COAL DAM

NDI No. PA 00464
PennDER No. 65-45

PHASE I INSPECTION REPORT
NATIONAL DAM INSPECTION PROGRAM

Coal Dam, Westmoreland County, Pennsylvania
NDI No. PA 00464, PennDER No. 65-45
Tributary of Brush Creek
Inspected 14 December 1979

FIELD SKETCH
COAL DAM

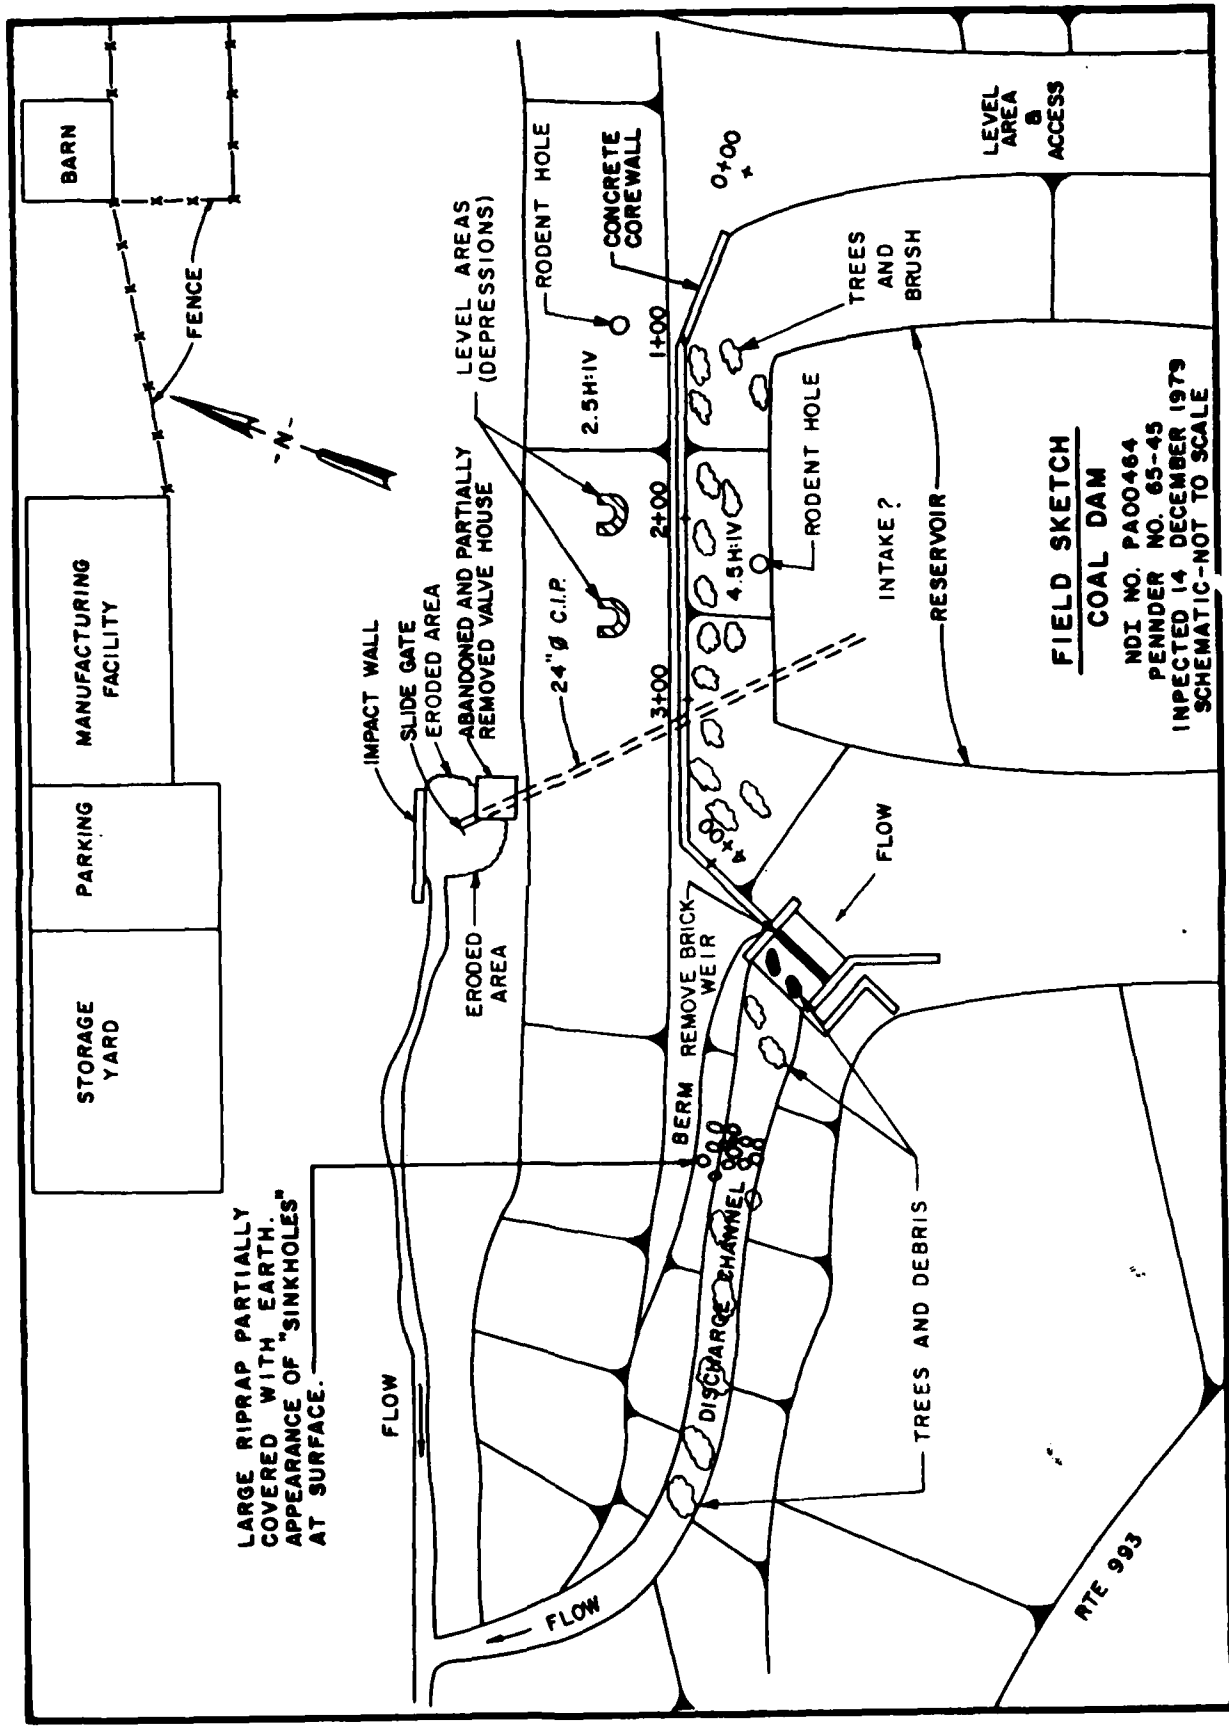
Several trees are growing in the channel.
Several "sinkholes" and some buildup of
debris is present in the channel.

LARGE RIPRAP PARTIALLY COVERED WITH EARTH. APPEARANCE OF "SINKHOLES" AT SURFACE.

The trees and debris should
be removed from the channel.

COAL DAM
TOP OF DAM PROFILE
TYPICAL CROSS-SECTION

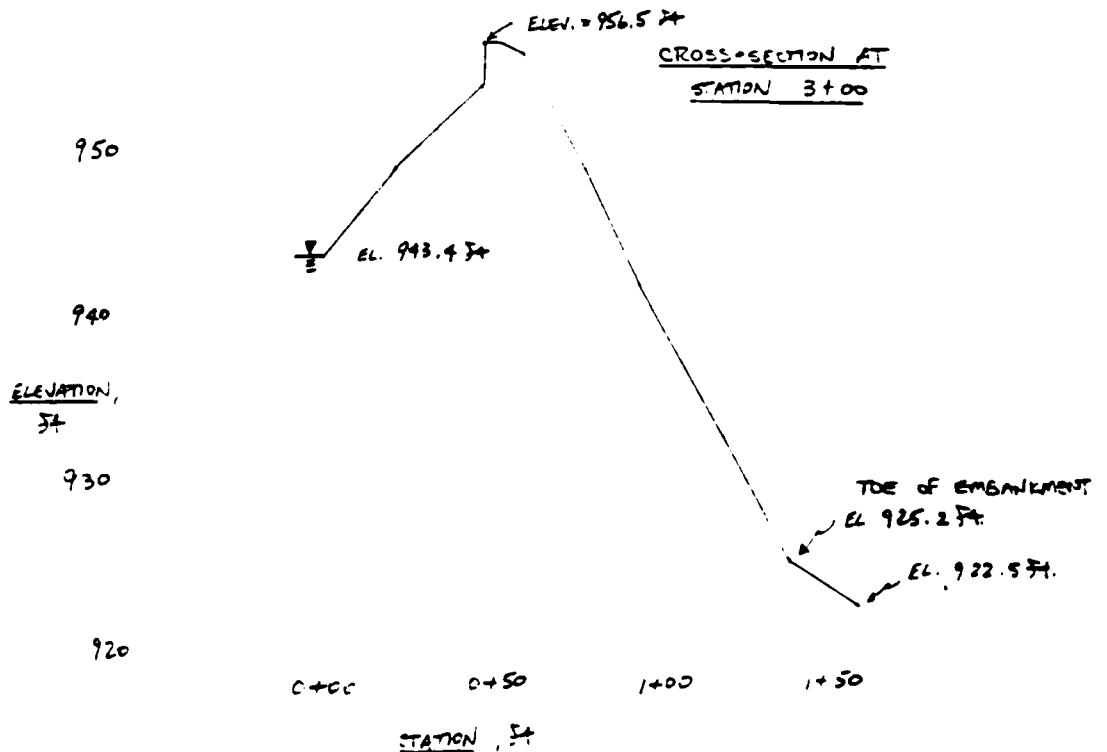
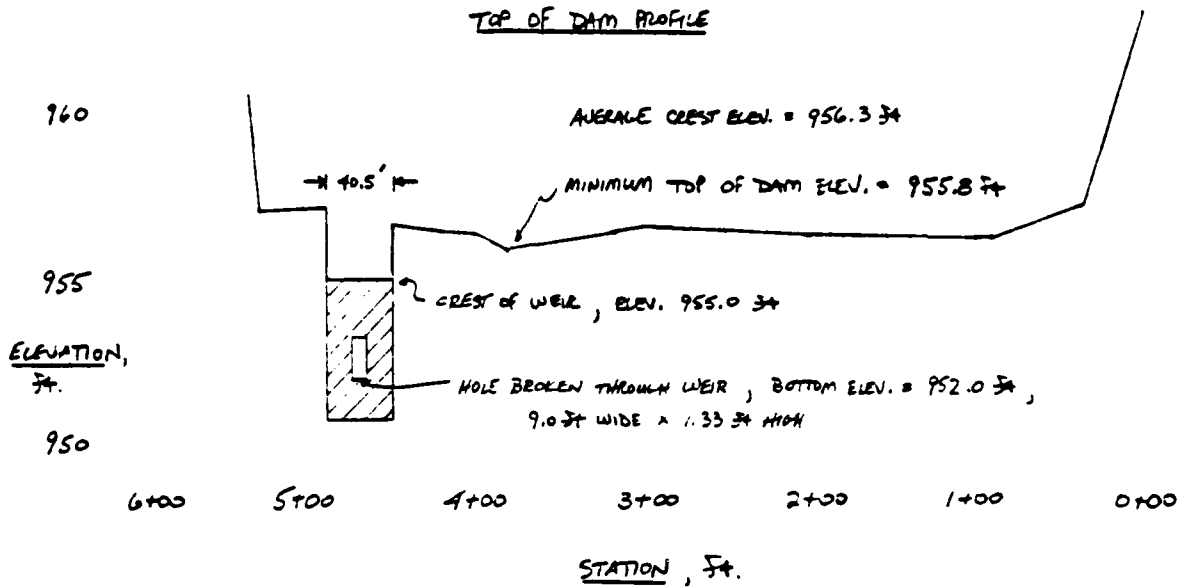
Visual inspection of the horizontal alignment indicated no problems. The top of dam profile (sheet A-14) shows that there is a low area on the crest at approximate Station 3+80. This area is approximately 0.5 ft. lower than the average top of dam elevation.
